10419 WILDLIFE RD

APPLICATION FOR APPROVAL TO USE AN EXISTING ON-SITE WASTEWATER TREATMENT & DISPOSAL SYSTEM
MECKLENBURG COUNTY - GROUNDWATER & WASTEWATER SERVICES
700 N. Tryon St., Suite 211 Charlotte, NC 28202
Phone: (704) 336-5103 Fax: (704) 336-6894

FILE #: 5690B

RE: Request for an Improvement Permit for lot 34 at The Sanctuary:
MCHD file # 5690B

PROPOSED PLOT PLAN

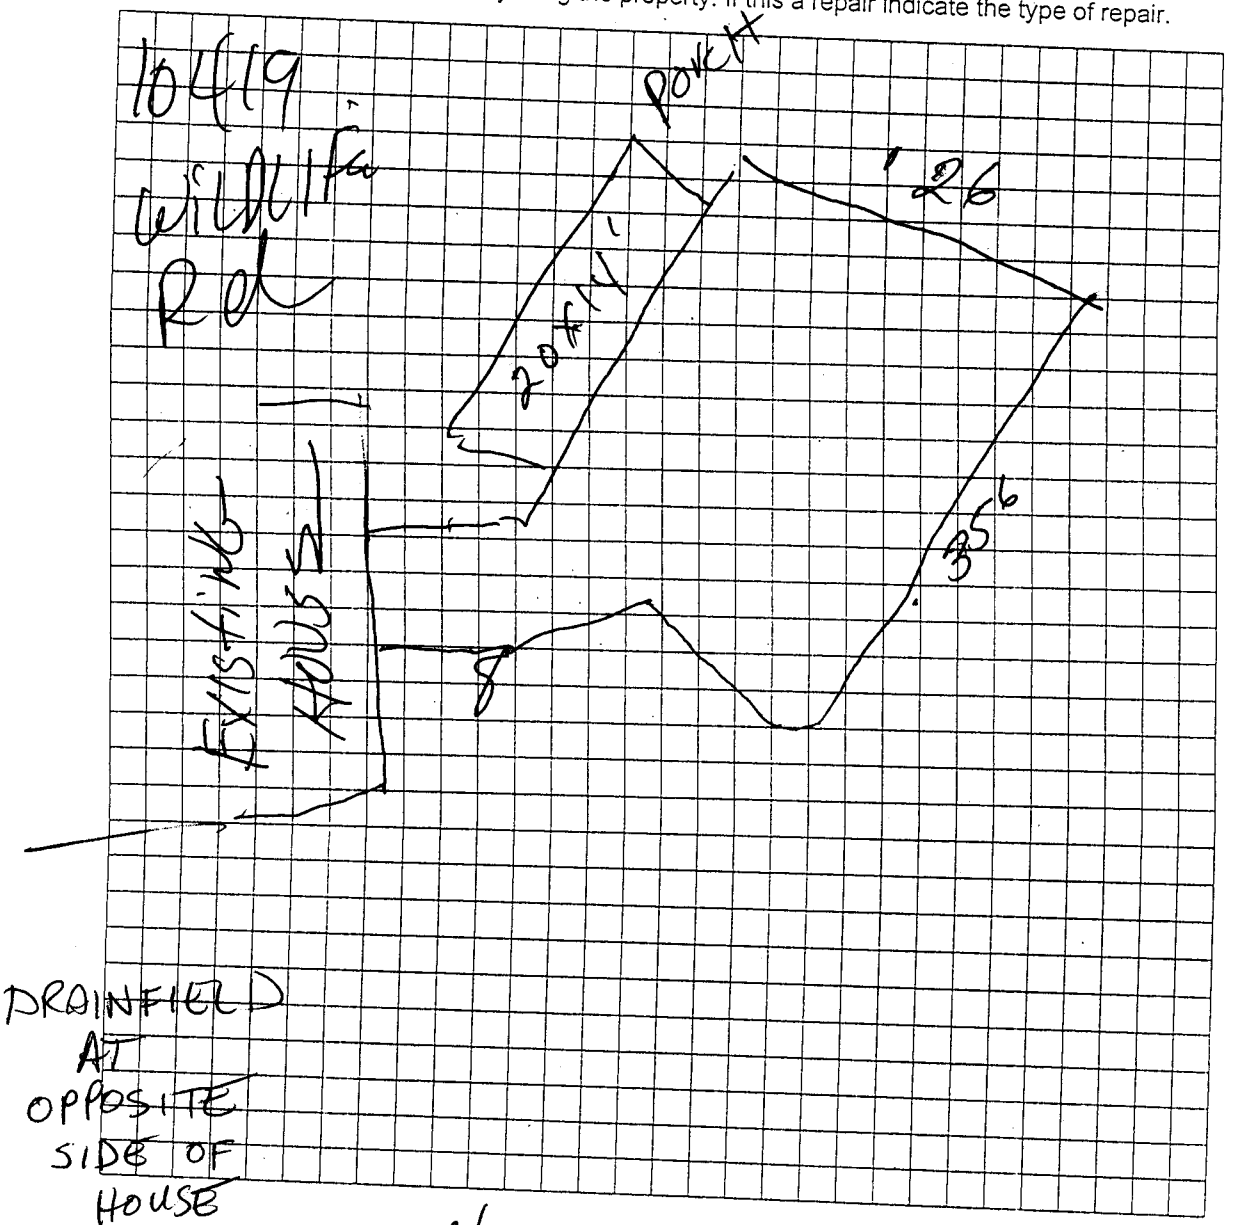
OK TO USE EXISTING SYSTEM.

← DRAINFIELD AT OPPOSITE SIDE OF HOUSE

PROPOSED PLOT PLAN

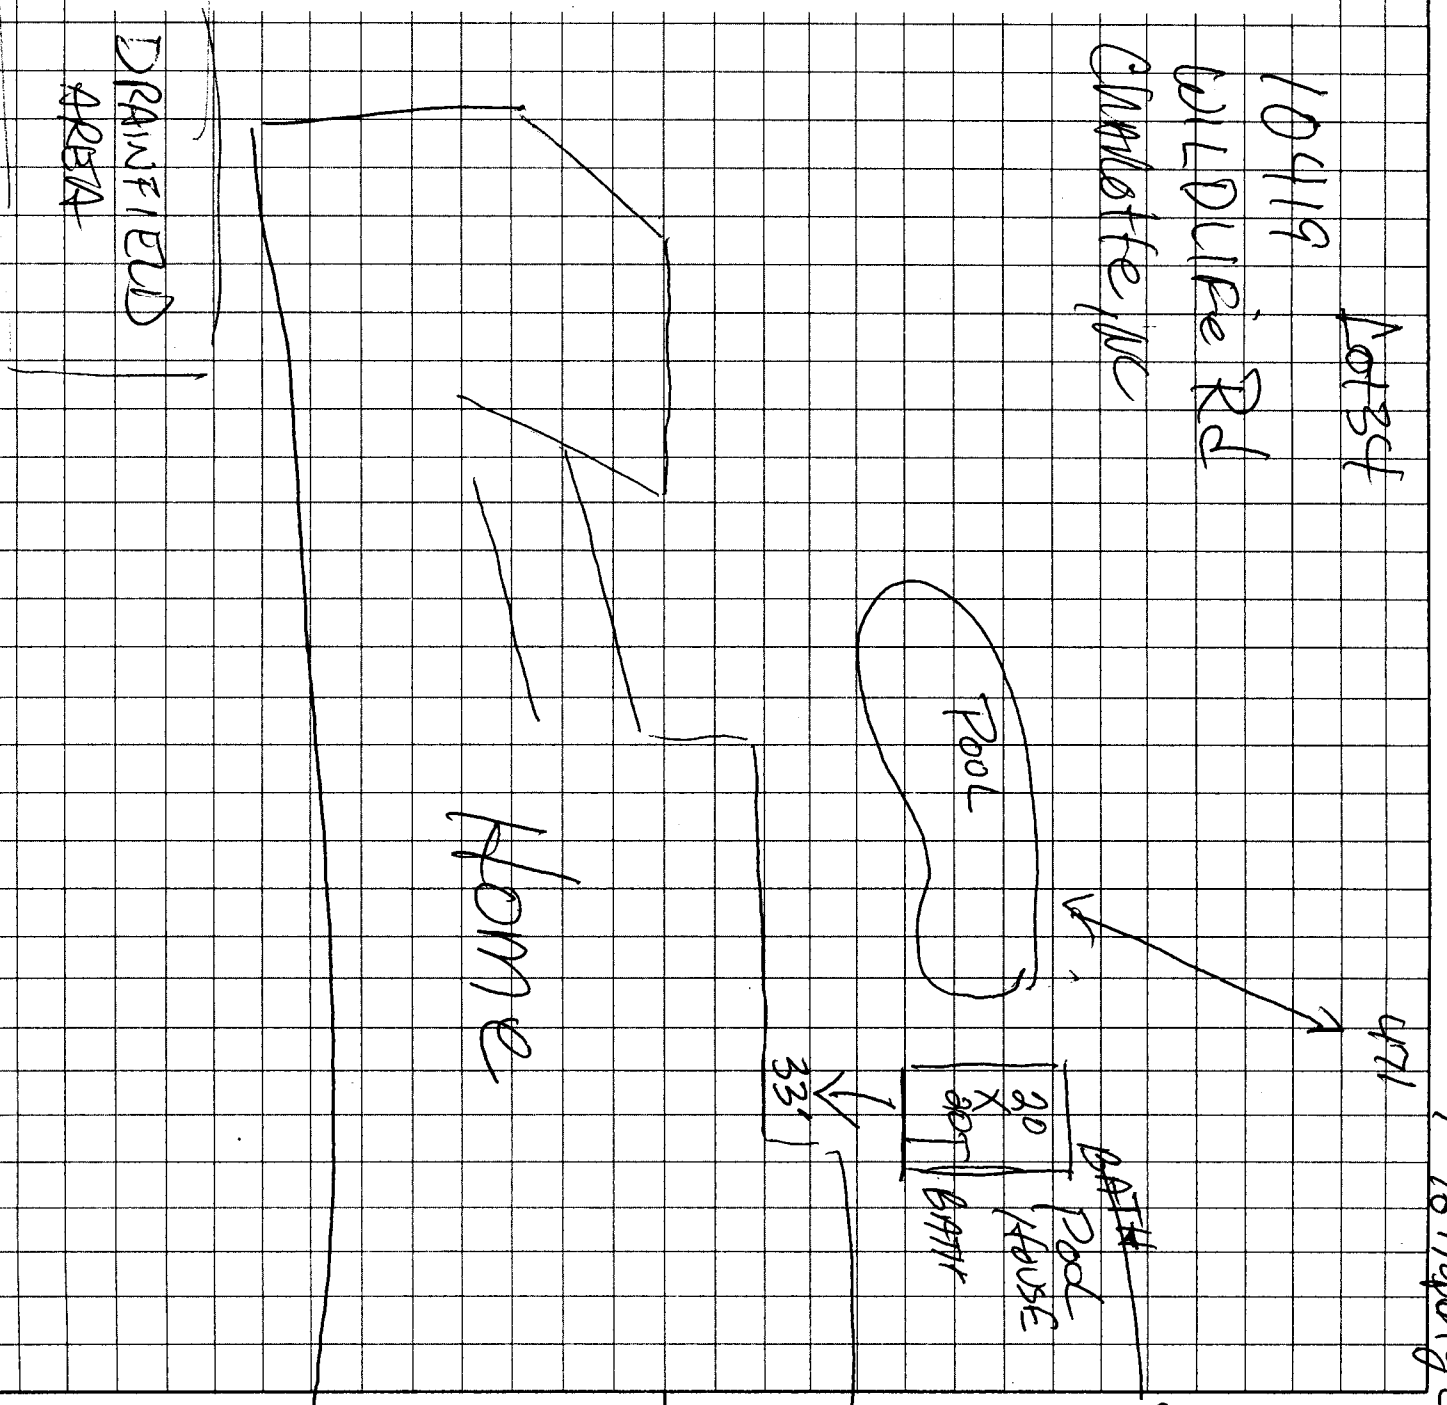
Pool house OK. Not over top Septic System

Change in Plot Plan

PLOT

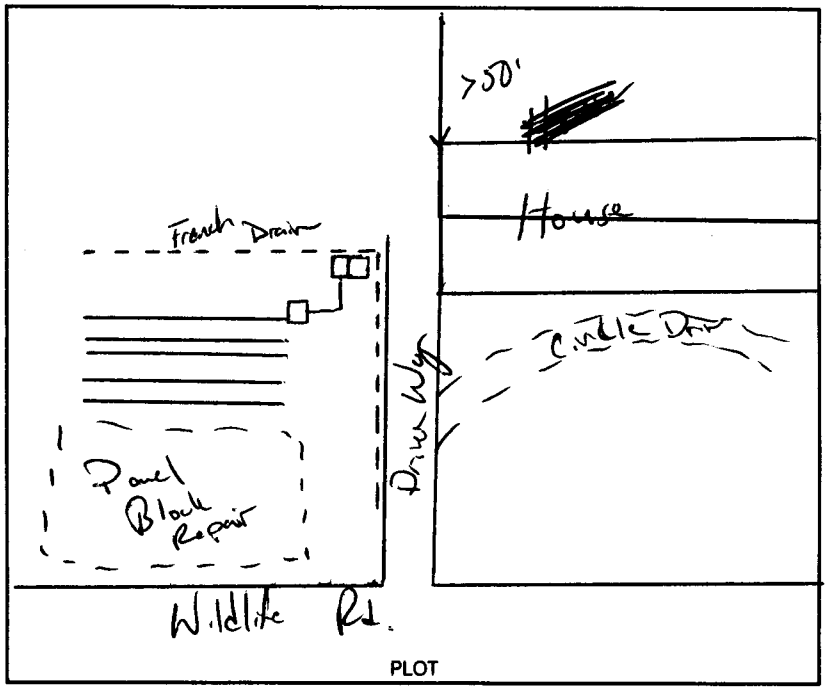
COMMENTS: Also needed is French Drain around septic system for surface water collection to not be allowed over system.

PLOT

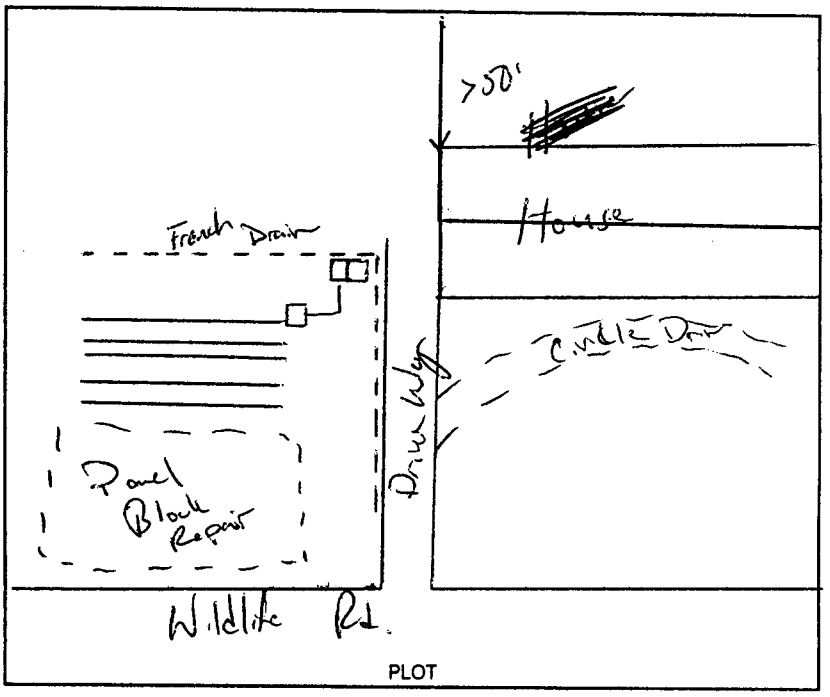
COMMENTS: Also needed is French Drain around septic system for surface water collection to not be allowed over system.

SKETCH OF SYSTEM INSTALLATION
(As-Built Drawing)

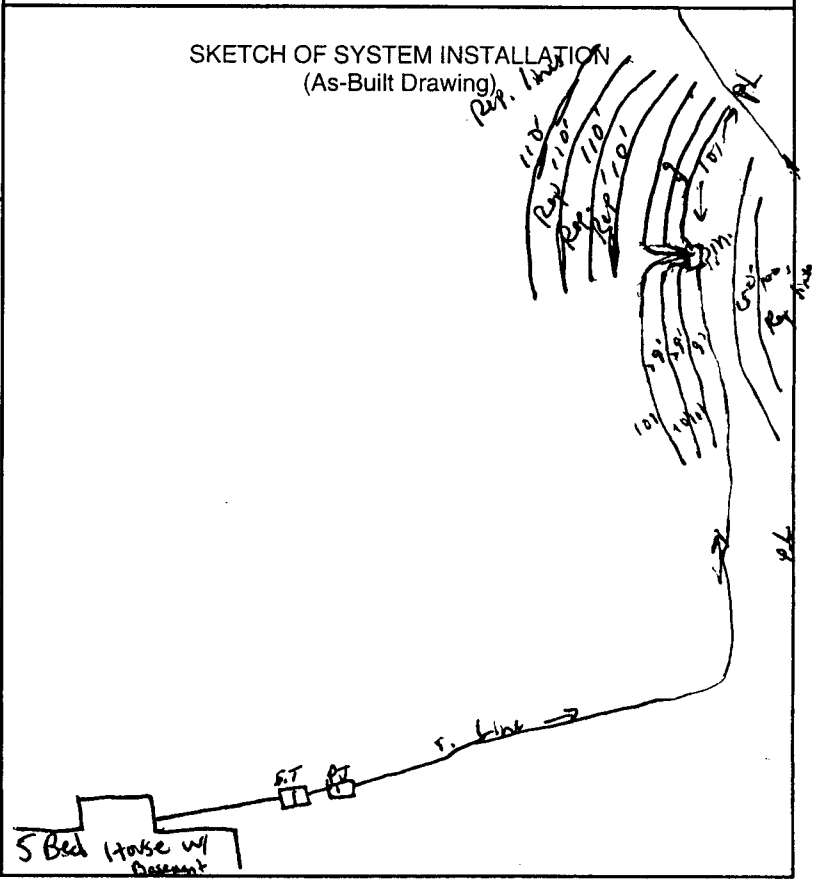
Comments: System Classification & Type: Type IIIb approved innovative System
Pump to pressure manifold to 6 laterals @ 100' length Changed → 304

SKETCH OF SYSTEM LAYOUT
(Proposed Layout)

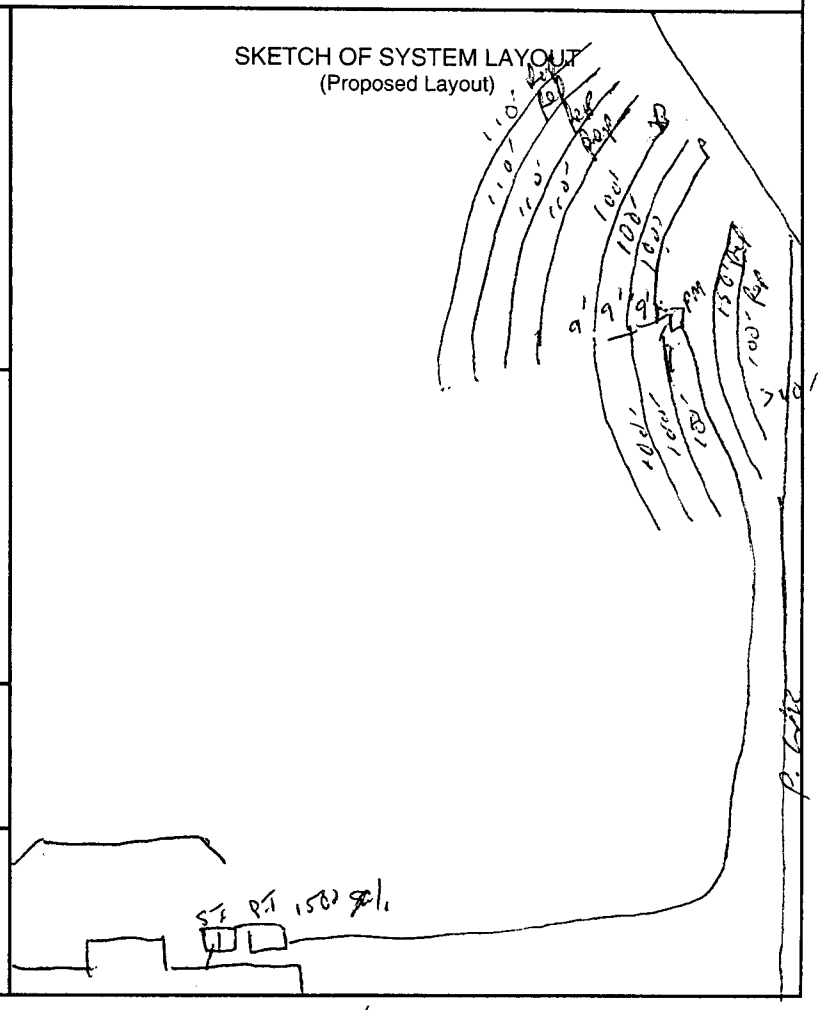
Comments: System Classification & Type: Install type 1116 pump to approved system. pump to 6 lines @ 100' each from pressure manifold

Proposed Retaining Wall
1/15/09

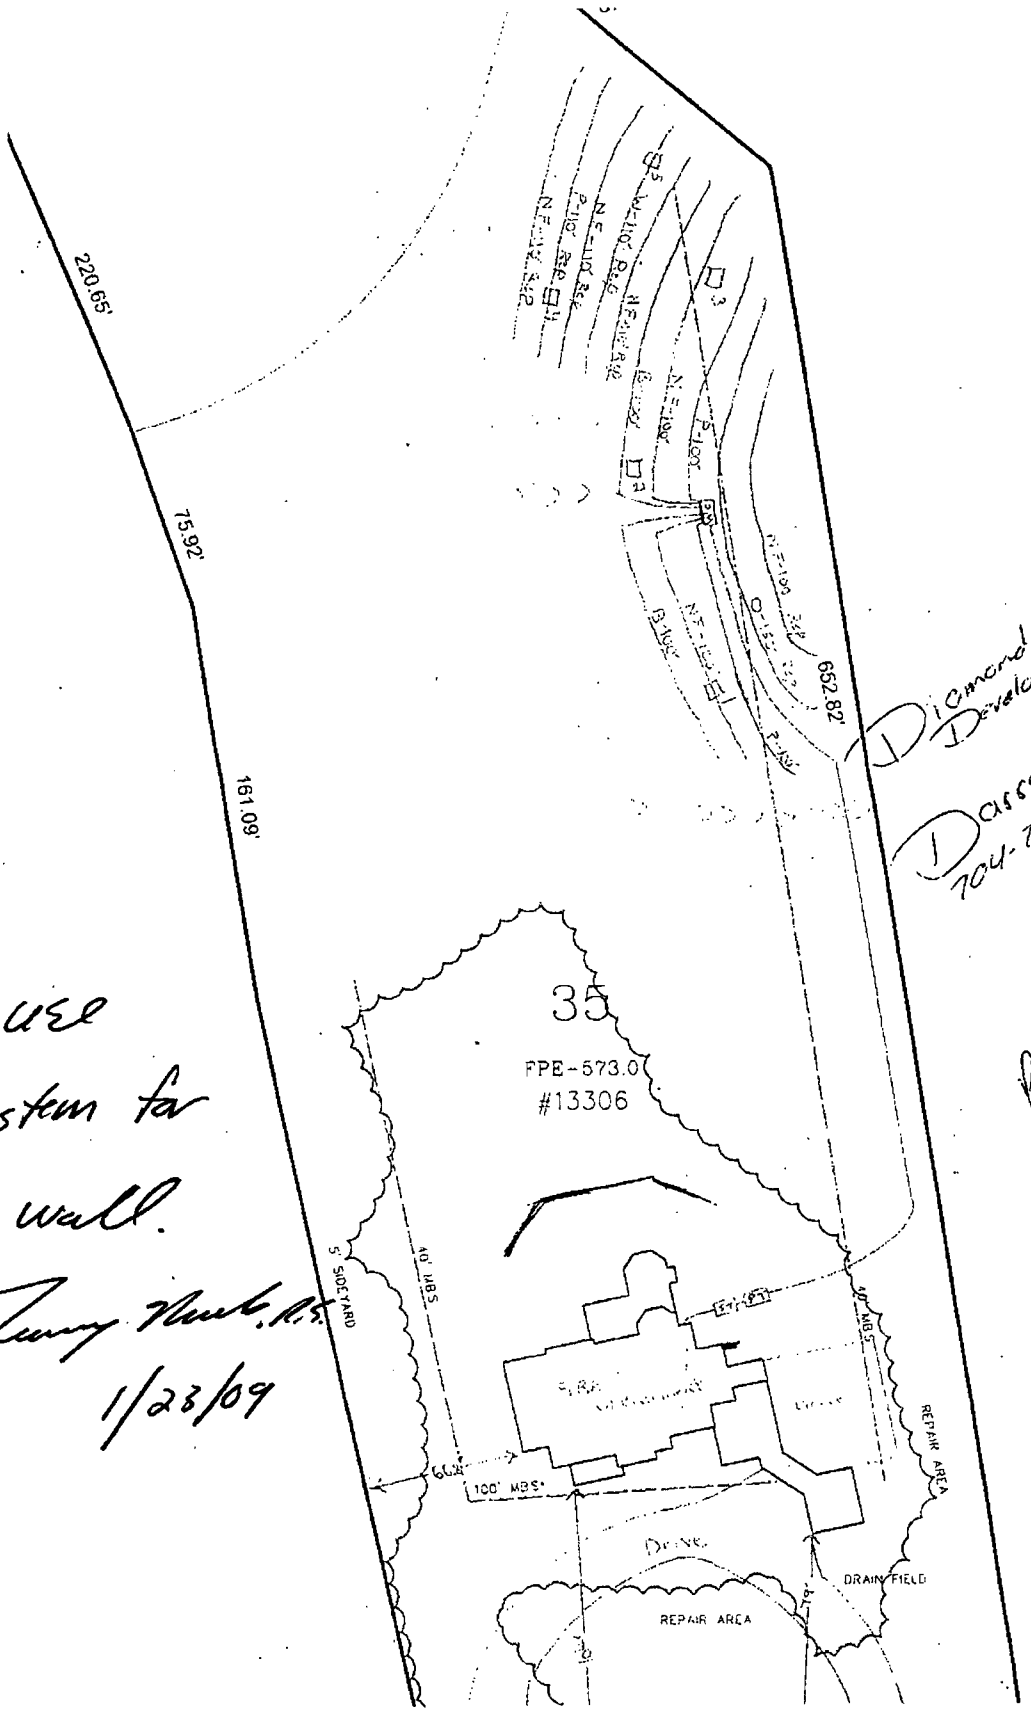
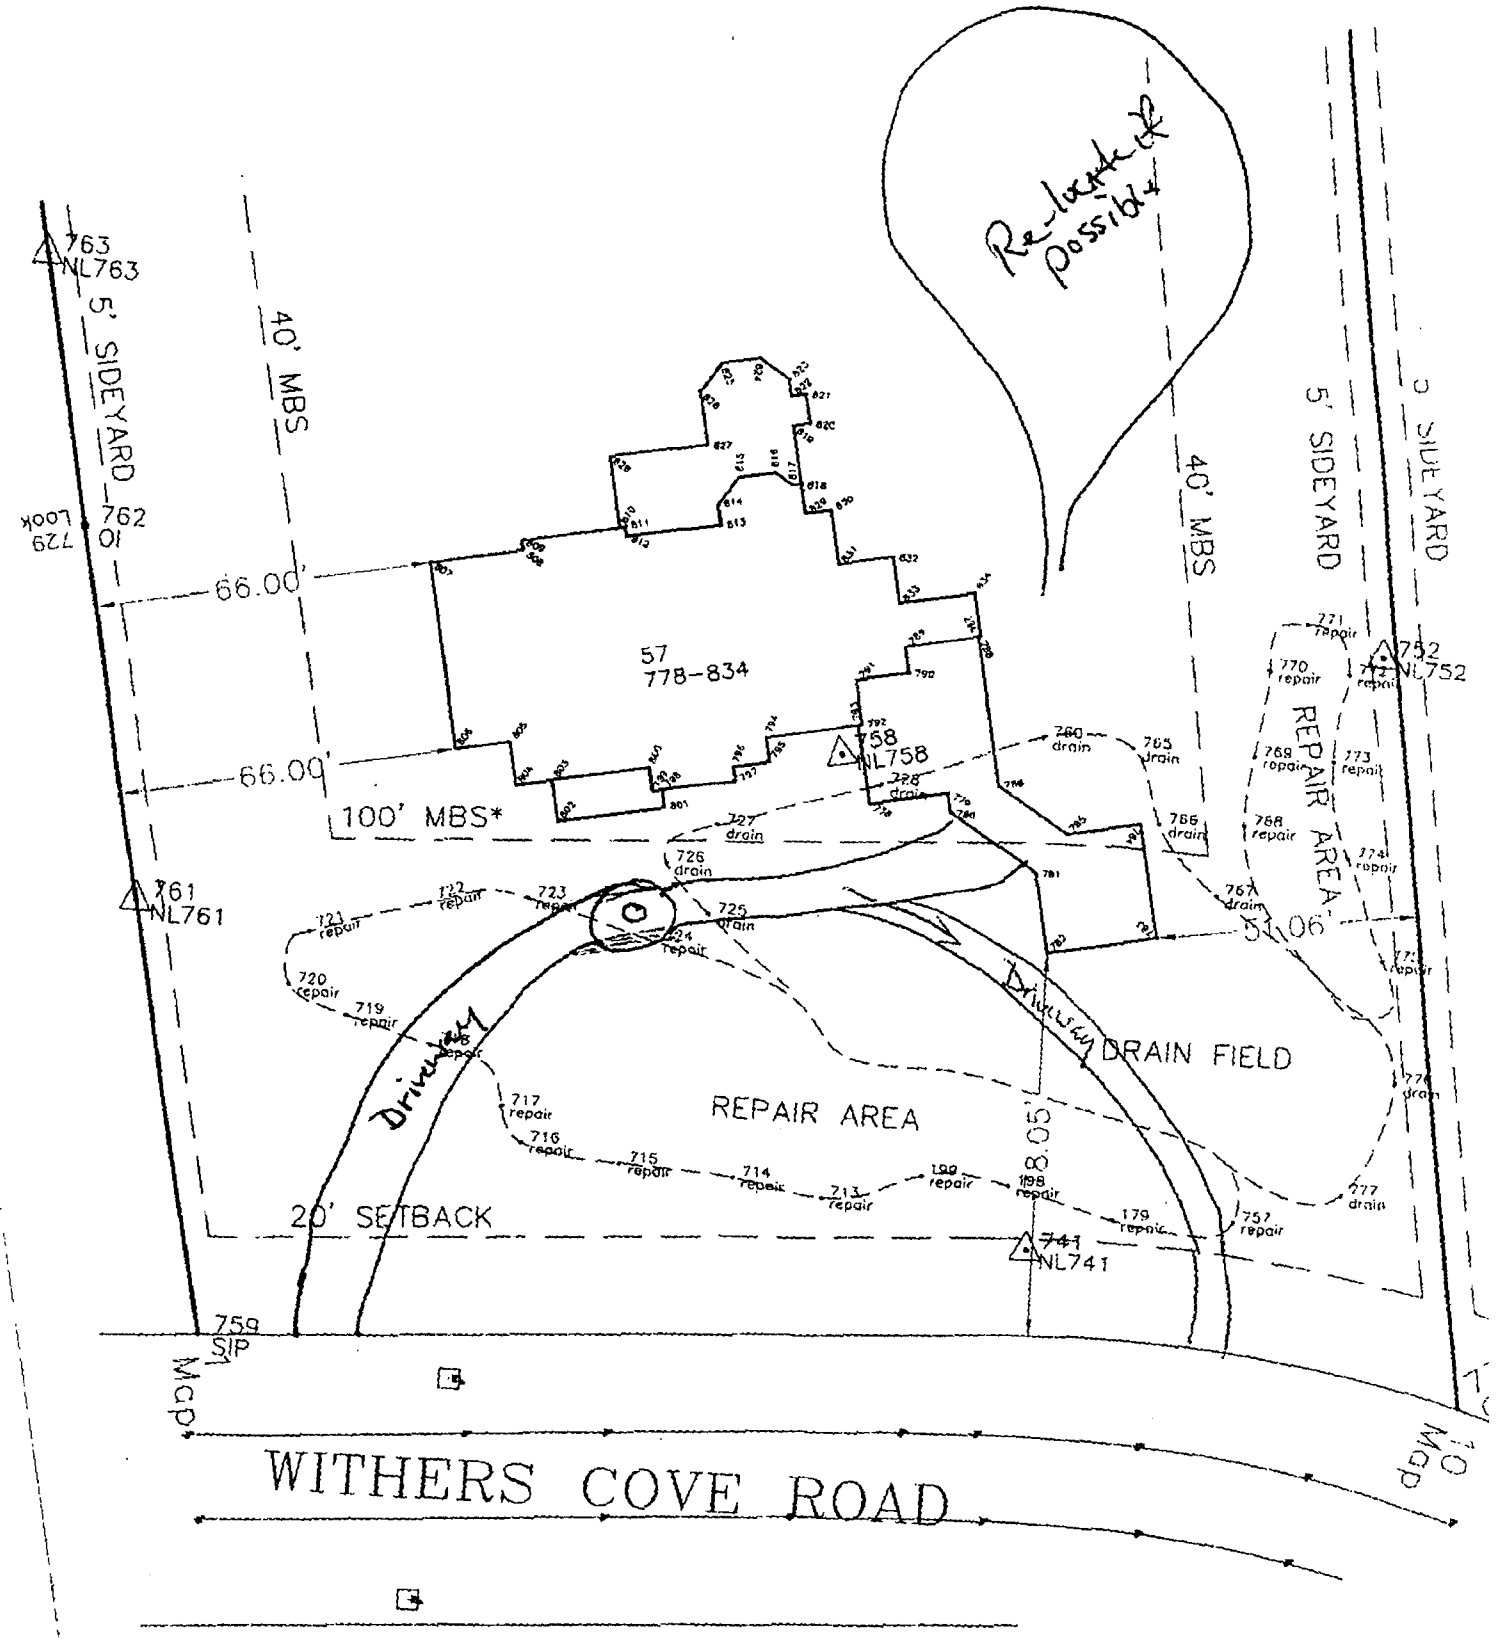
O.K. to use existing system for a retaining wall.

Re-locate if possible
763
NL763
5' SIDEYARD
40' MBS
762
729
Look
66.00'
57
778-834
66.00'
758
NL758
100' MBS*
761
NL761
726 drain
725 drain
724 repair
727 drain
760 drain
765 drain
766 drain
768 repair
769 repair
770 repair
771 repair
773 repair
774 repair
752
NL752
5' SIDEYARD
40' MBS
REPAIR AREA
51.06'
DRAIN FIELD
Driveway
Driveway
REPAIR AREA
80.05'
20' SETBACK
741
NL741
759
SIP
Map
WITHERS COVE ROAD
Map
